From: Mess, Camie
Sent: Friday, January 26, 2018 4:07 PM
To: Whitney Hudson (whudson@bdarchitects.com)
Subject: BAR Action- January 17, 2018 - 600 West Main Street

Certificate of Appropriateness Application
BAR 16-01-04
512-514, 600 West Main Street
Tax Parcel 290007000, 290006000, and 290008000
Heirloom West Main Development LLC, Owner/Heirloom West Main Development LLC, Applicant
Changes of material from Approved COA

**CITY OF CHARLOTTESVILLE
BOARD OF ARCHITECTURAL REVIEW
STAFF REPORT
January 17, 2018**

Re: 510-600 West Main Street: BAR approval request for substitution of exterior cladding materials

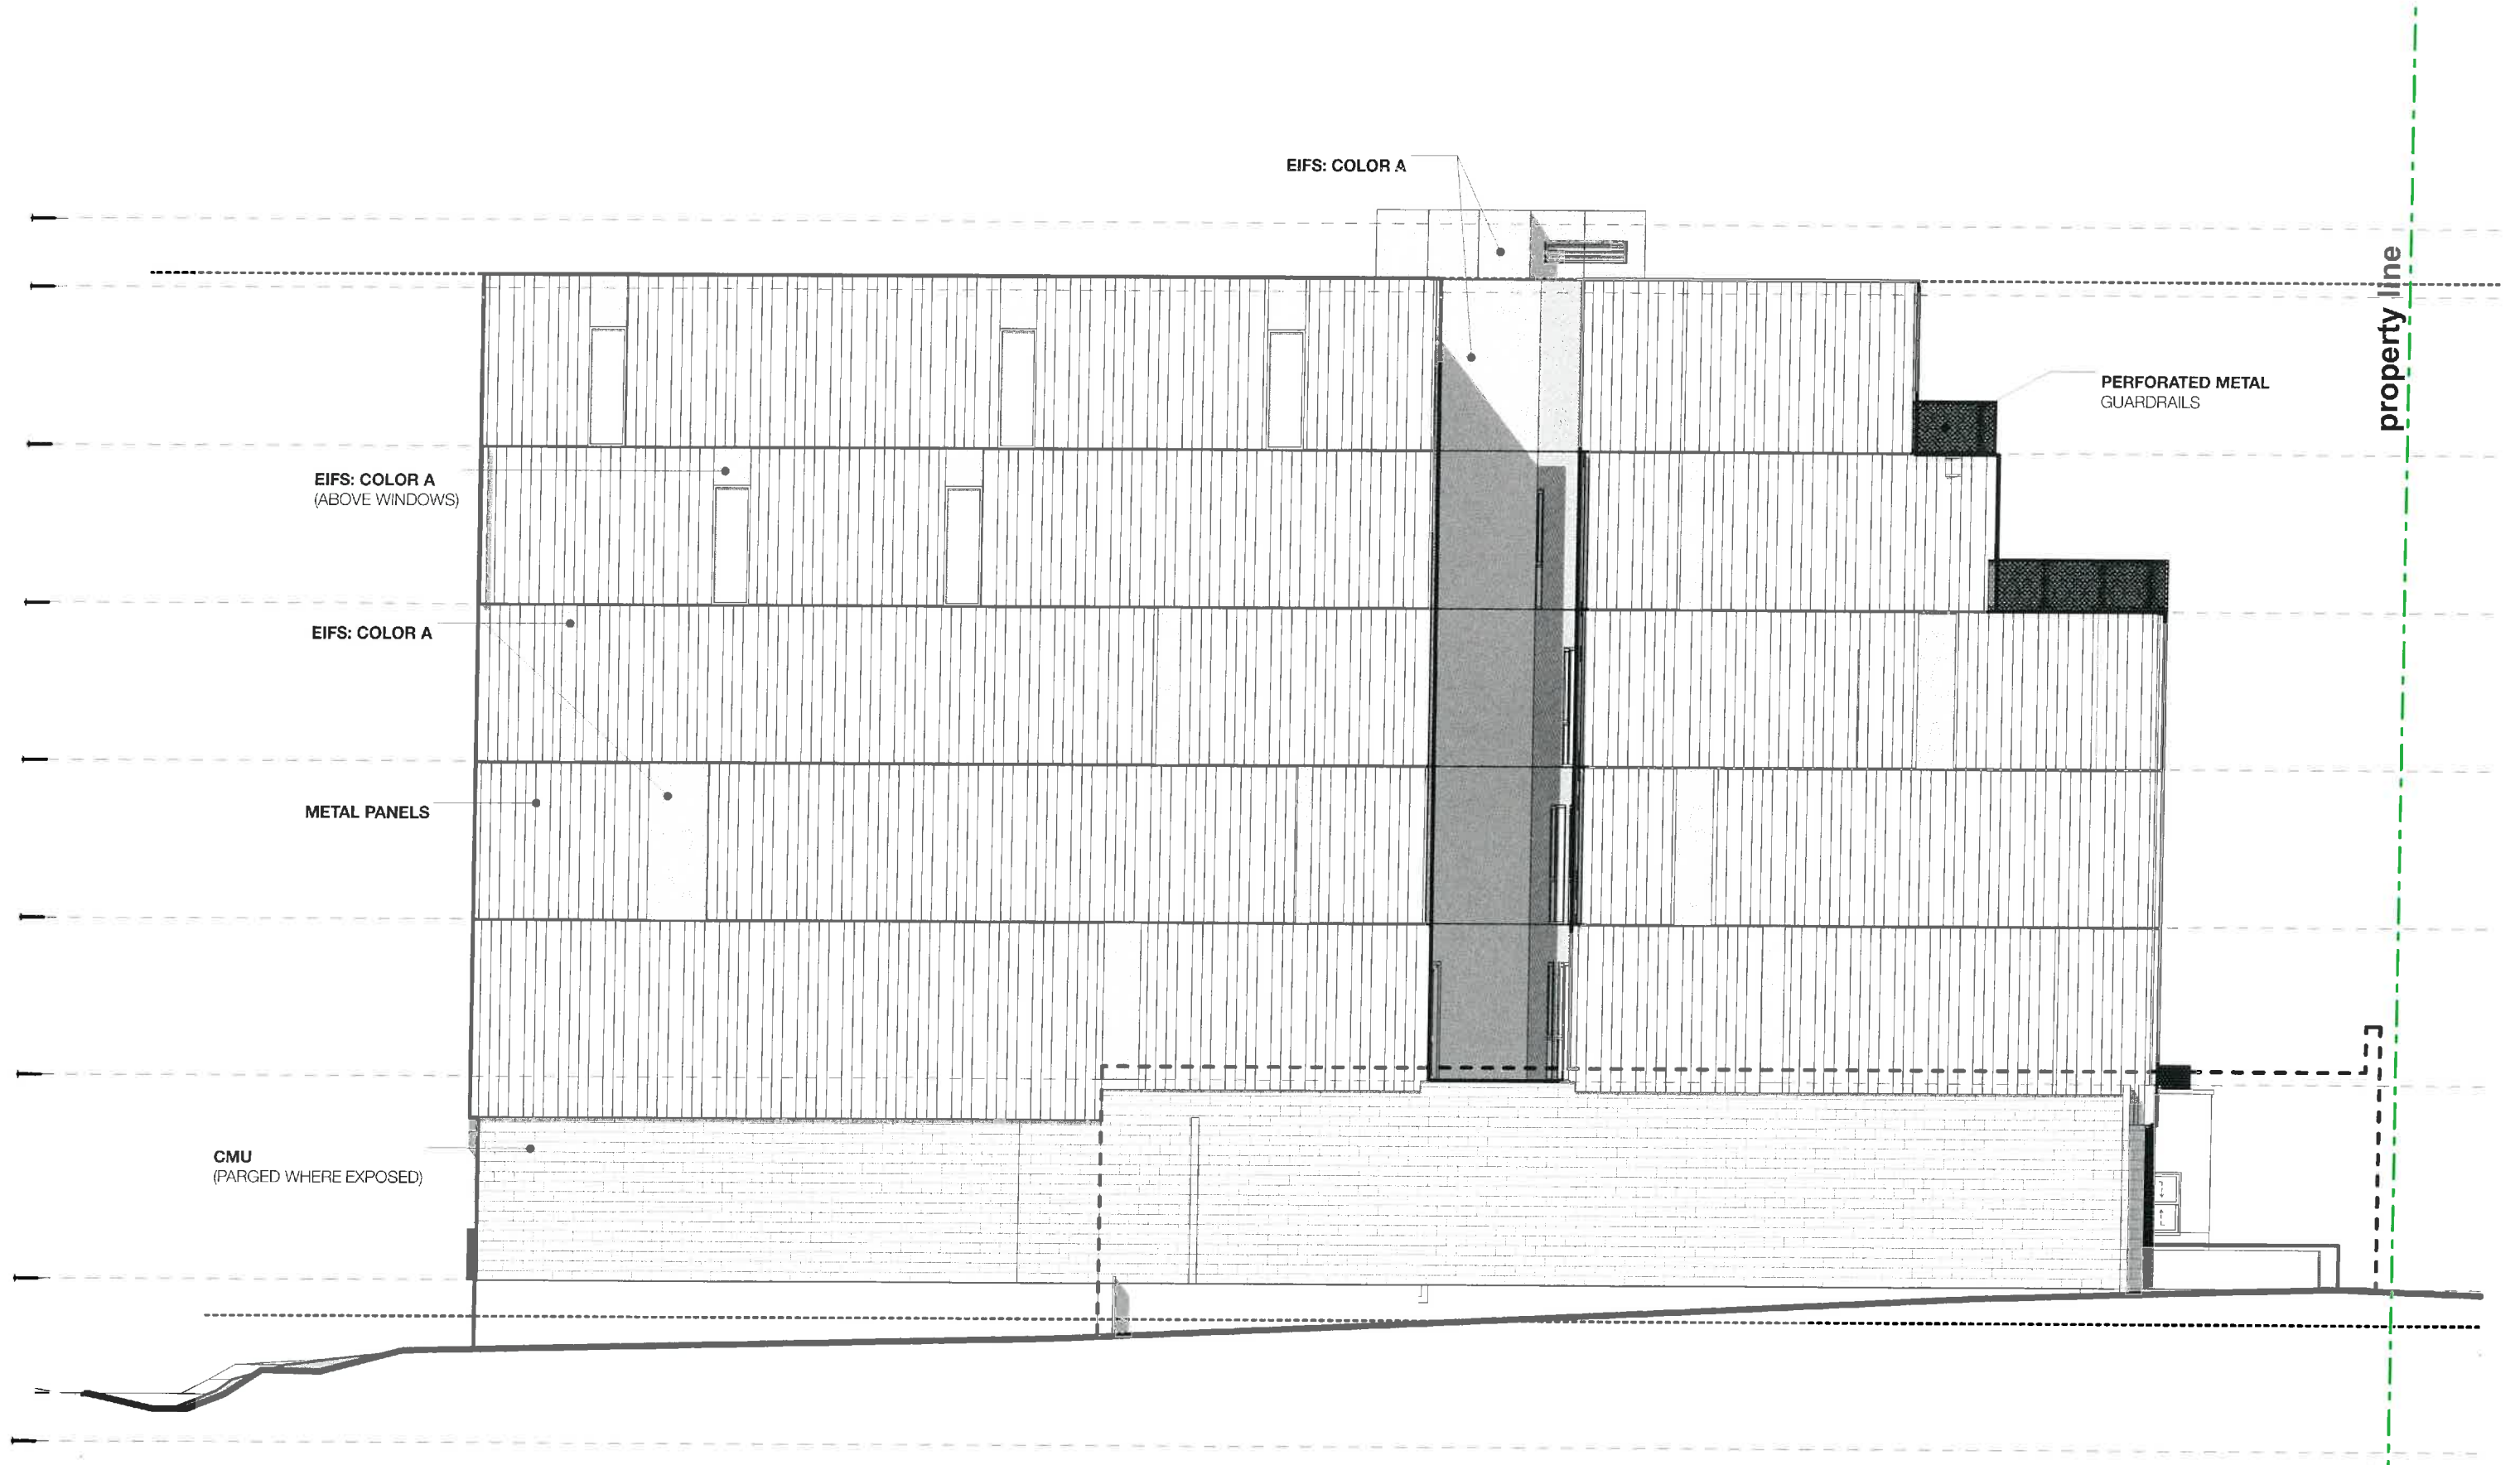
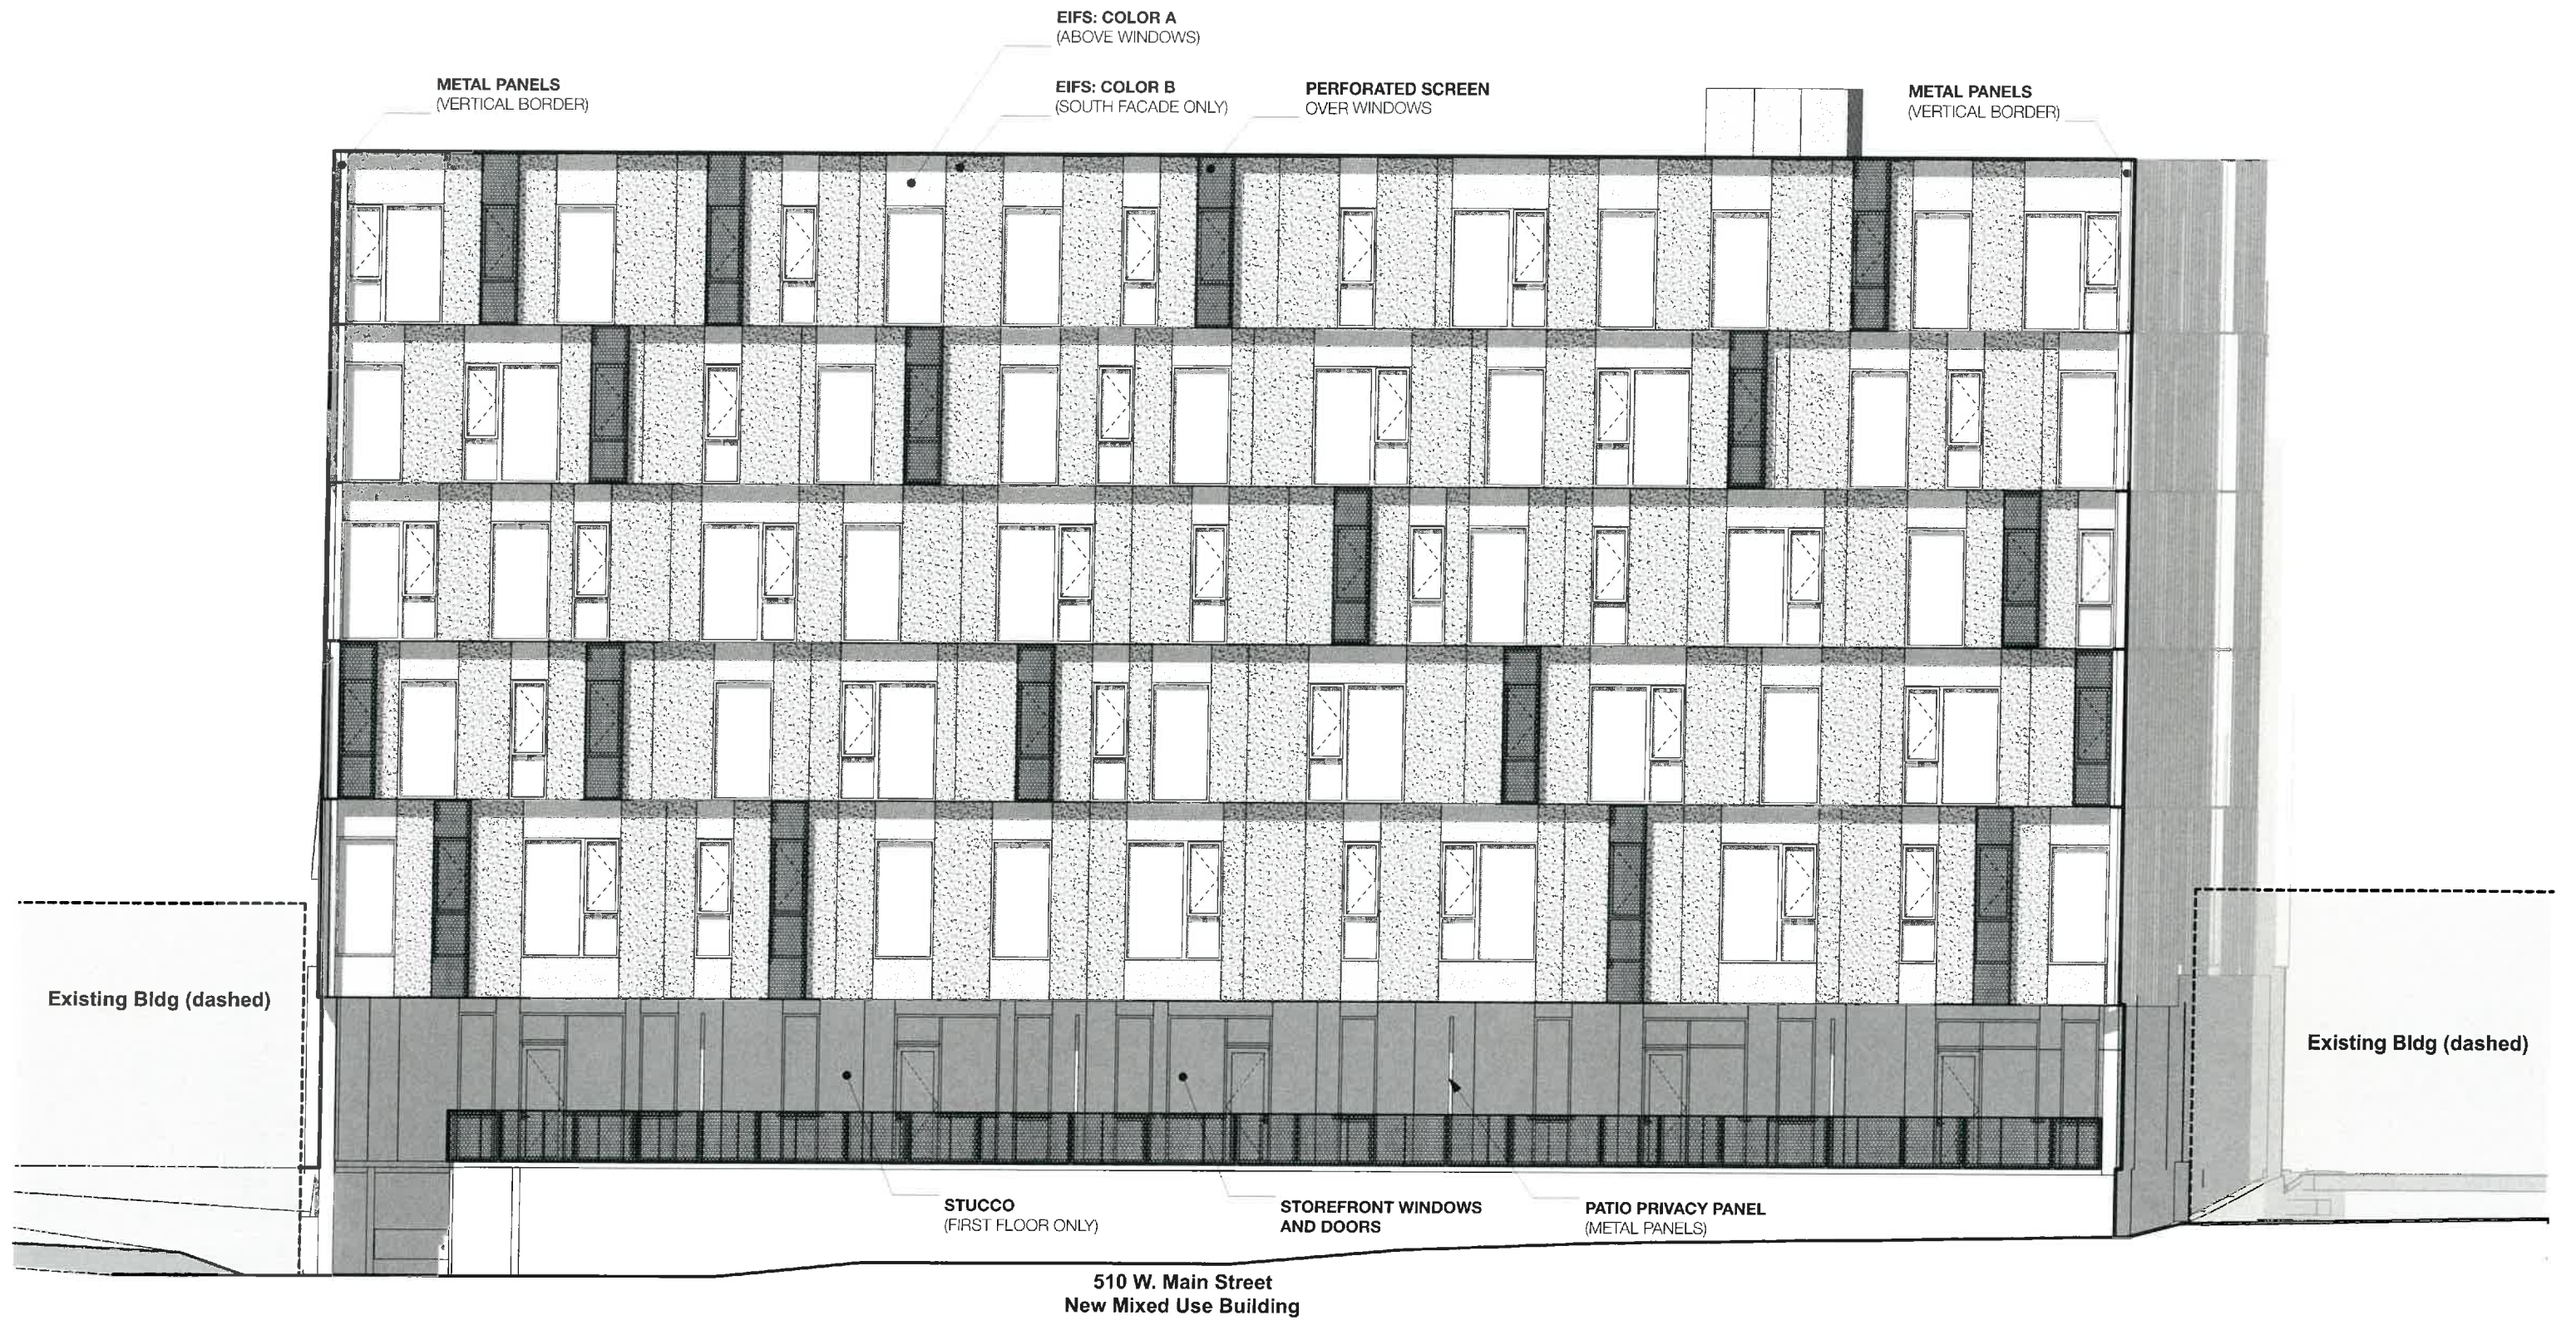
STUCCO
color: SW7642 Pavestone
texture: smooth fine sand
(proposed substitute for fiber cement C)

EIFS A
color: SW7069 Iron Ore
texture: savannah
(proposed substitute for fiber cement A)

EIFS B
color: BM HC166 Kendall Charcoal
texture: savannah
(proposed substitute for fiber cement B)

perforated metal color
RAL 7037 SD Matte
